**CITY OF ST. HELENS PLANNING DEPARTMENT
STAFF REPORT
Variance V.1.24**

ZONING: Mixed Use, MU
LOCATION: 4N1W-4AC-305
PROPOSAL: Variance to allow a reduced distance between windowed wall and walkway for dwelling unit, which is part of a mixed-use building under construction.

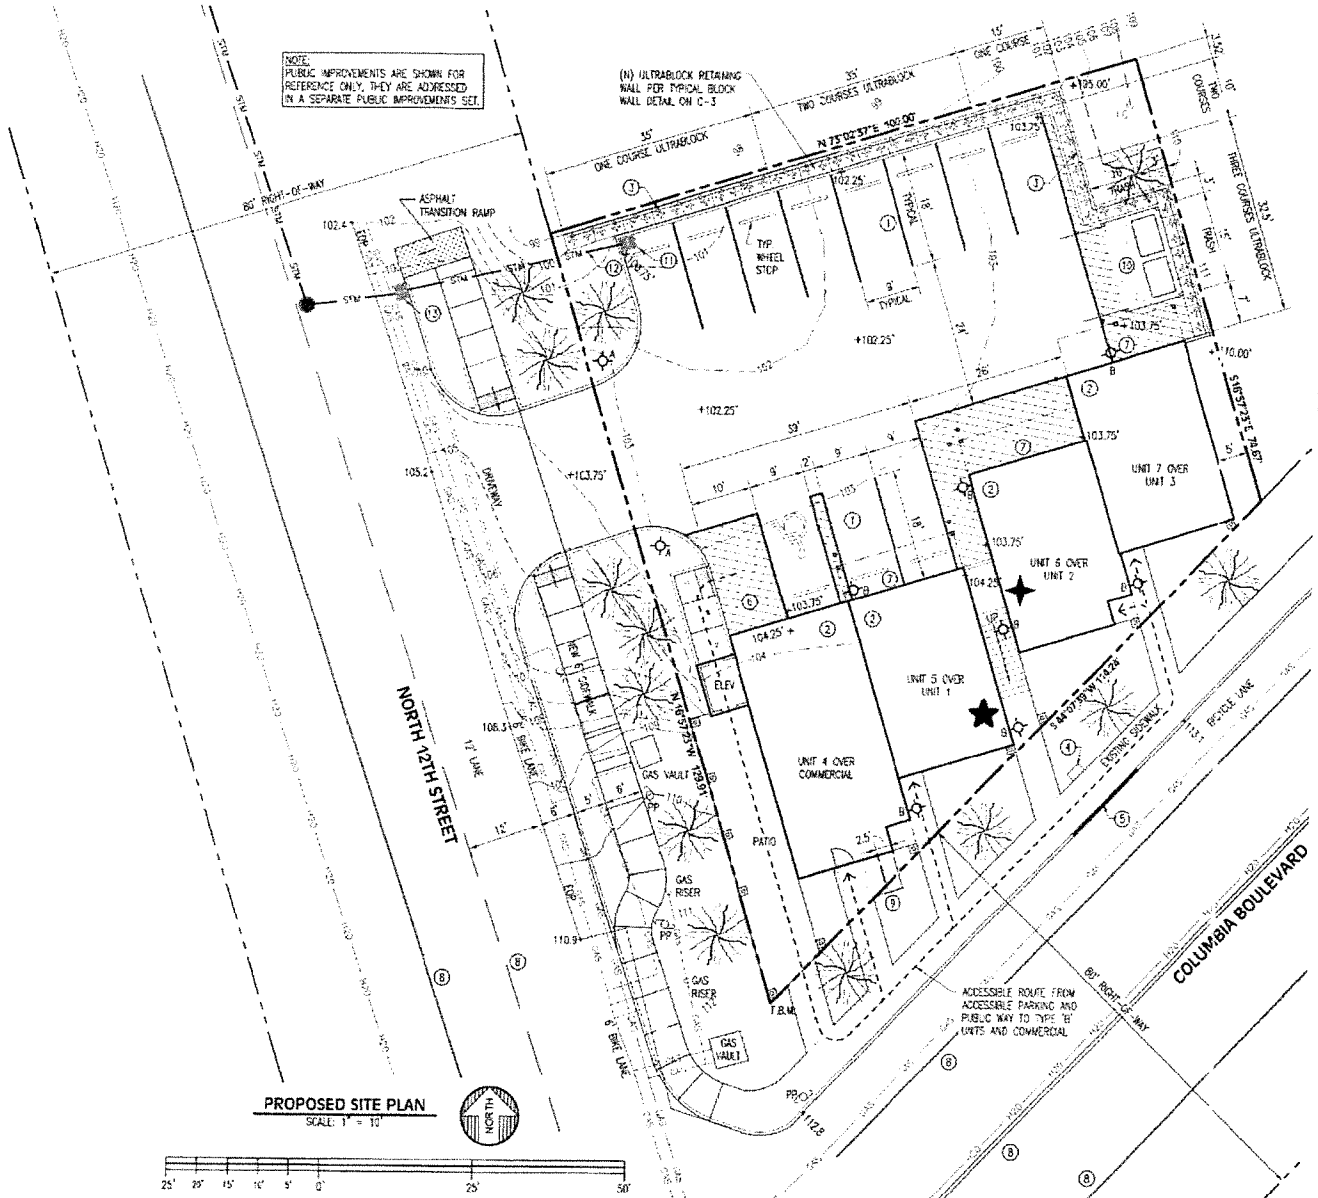
There is a windowed wall within 8' of ground level immediately adjacent to a walkway. The minimum distance is not met, and the Variance request is to allow zero feet.

Above: Excerpt of the site plan for the development proposed. The five-point star is the general location of the window in question, which has been installed. The four-point star is another window identified in the plans for the 2020 application as an issue but omitted for construction.

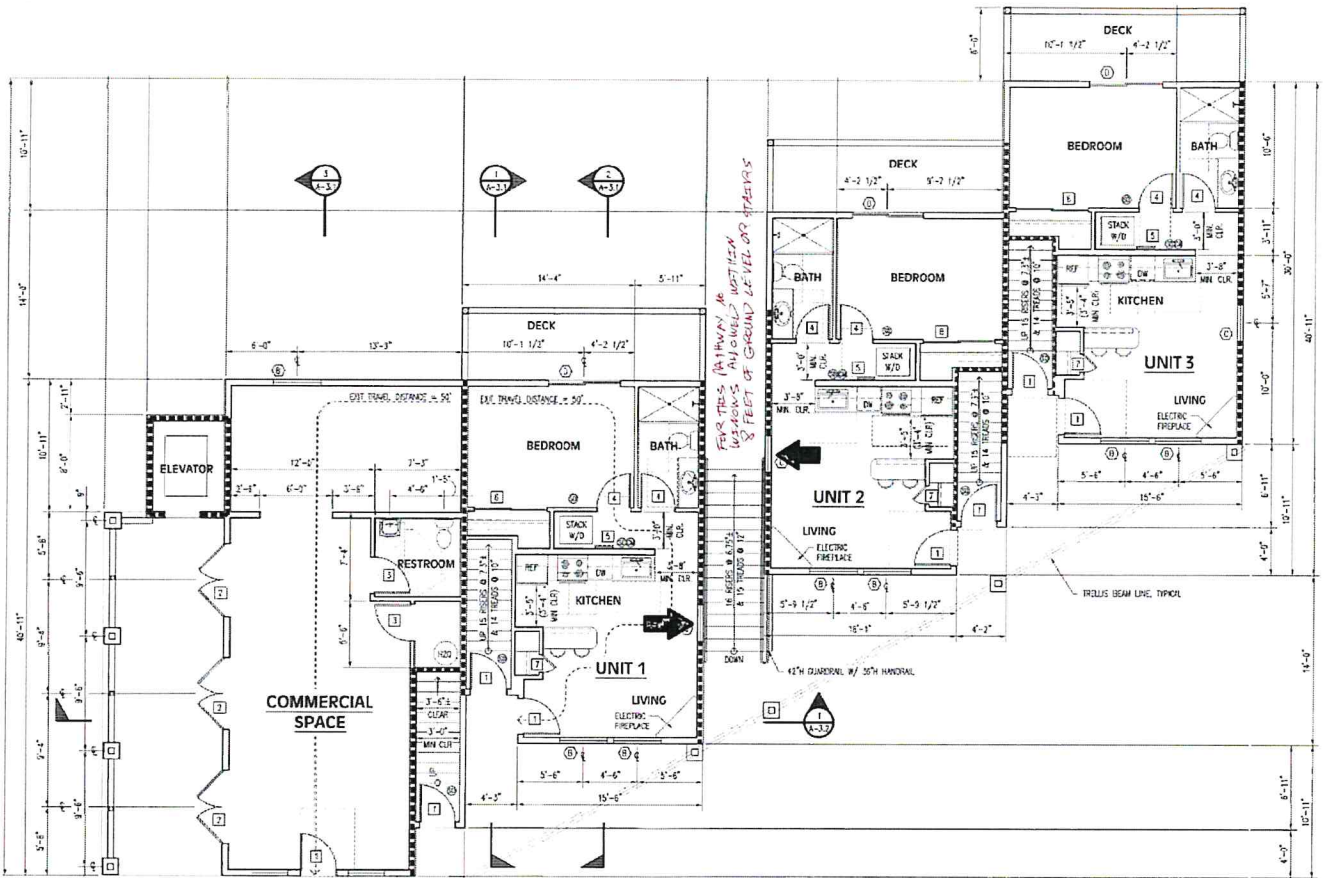
Above: Excerpt of the street level floor plan for the development proposed. The walkway in question cuts through the center. The arrow on the left points to the window in question, which has been installed. The arrow on the right points to a window that was originally proposed but omitted. **Below left:** The window in question. **Below right:** The walkway area in question. Note no window along the abutting wall on the right side which was omitted for construction.

- Staff comment(s): Regarding the self-imposed aspect, the proximity to windowed walls to the walkway was identified as an issue, but only one of two that were identified as problems were omitted. Applicant notes that the window was left by the engineer (i.e., the design professionals who prepared the plans) and identifies the issue as a mistake.

Things to consider include requiring opacity to the window to minimize the ability to peer into the dwelling unit area from the outside and maybe more extensive modifications, if the Commission finds it can approve this. If not approved, the window in question will need to be replaced with wall.
